## Attention: 5TM, 5TE, and GS3 calibrations

Figure 1.

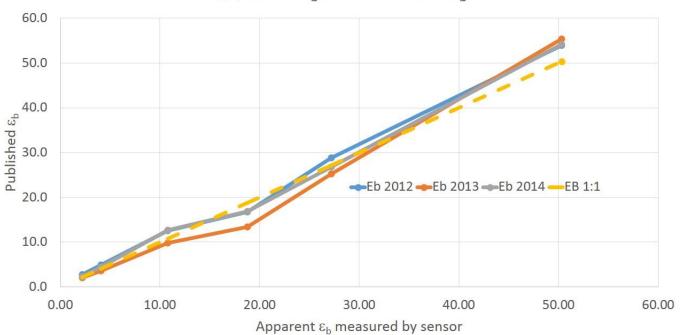
Figure 1. Note that the dielectric output by the probe is very close for 2012 (blue line), and our current sensors (gray line). Sensors produced in 2013 read lower in the region between a dielectric of 10 - 20. A "perfect sensor" should fall directly on the 1:1 line (yellow).

Figure 2.

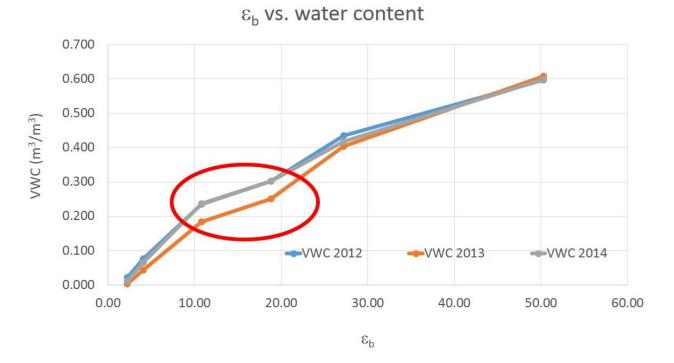
Figure 2. The Topp equation was used to assess the impact of the probe output on water content. The region circled in red highlights the area most greatly affected by the shift in output for the sensors.
